Technical Service Bulletin: TSB110330

Released Date: 20-Dec-2011

New Water Pump and Service Kits for K19 and QSK19

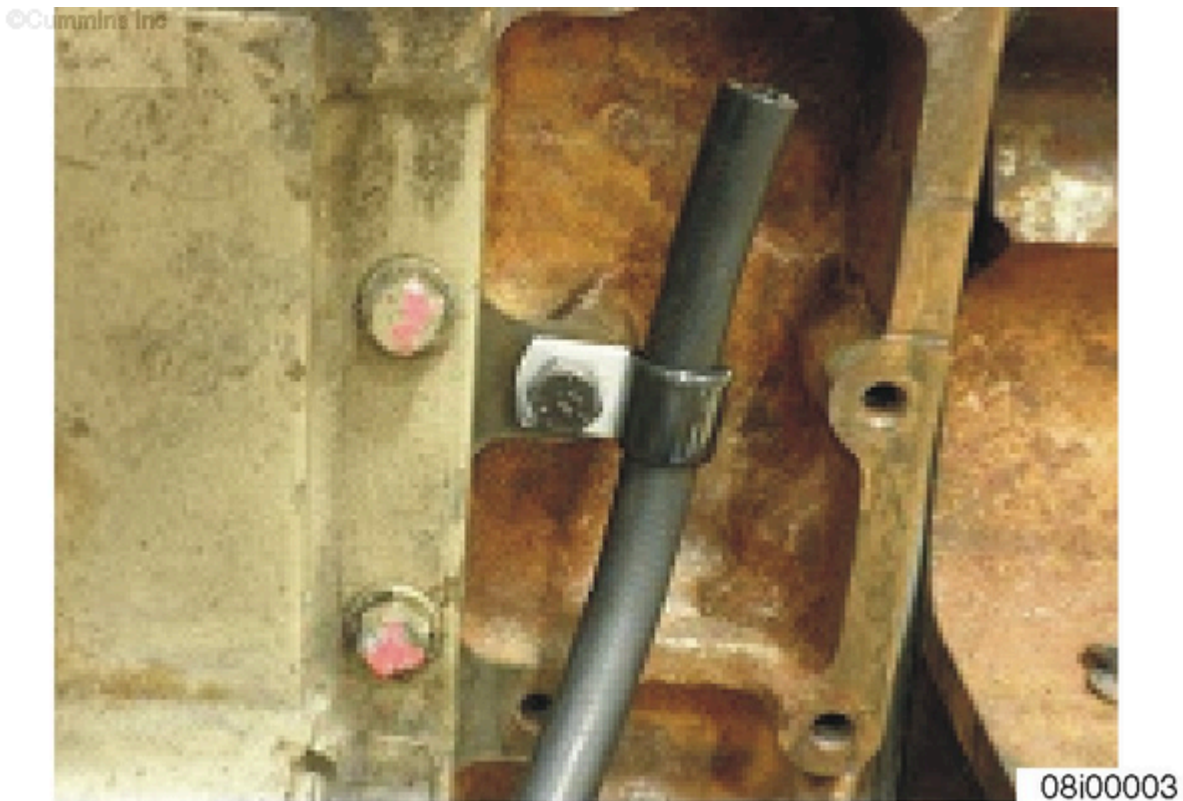
Coat the first two barbs of the 90° fitting, Part Number 4998211, with medium strength silicone sealant, Part Number 3823494, or equivalent. Drive it into the weep hole of the pump until the shank touches the pump housing.

Do **not** put sealant on the tip of the barbed fitting, as this could cause contamination of the pump and/or plugging of the fitting upon installation.

Once the fitting is installed in the weep hole, install the hose, Part Number 4998213, by hand, over the fitting until the end of the hose touches the shank of the fitting.
